# Access Compliance Report

## Public Rights-of-Way

| Intersection ID: 7038                   | Main Street: BROOKWOOD_RD | Cross Street: WOODWIND_ST               | Location: SE           |
| ADA ID: 3D1EAAEE9DD4                    | Ramp Type: BlendTrans1    | Initial Pass/Fail: Fail                 | Overall Compliance: No |

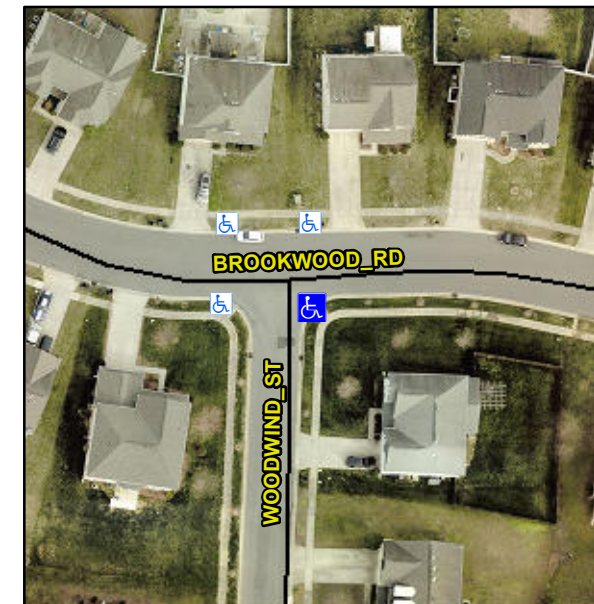
**CURB GAP 1.0**

**Not Found, R304.5.1**

| Compliance | Description           | Data | Compliance | Description                 | Data |
|------------|-----------------------|------|------------|-----------------------------|------|
| No         | Ramp Width (in)       | 47.0 | Yes        | BlendTrans XSlope (%)       | 1.3  |
|            |                       |      | No         | Curb Slope (%)              | 26.3 |

**Remove & Replace Curb Ramp With Two New Directional Ramps or Equivalent.**
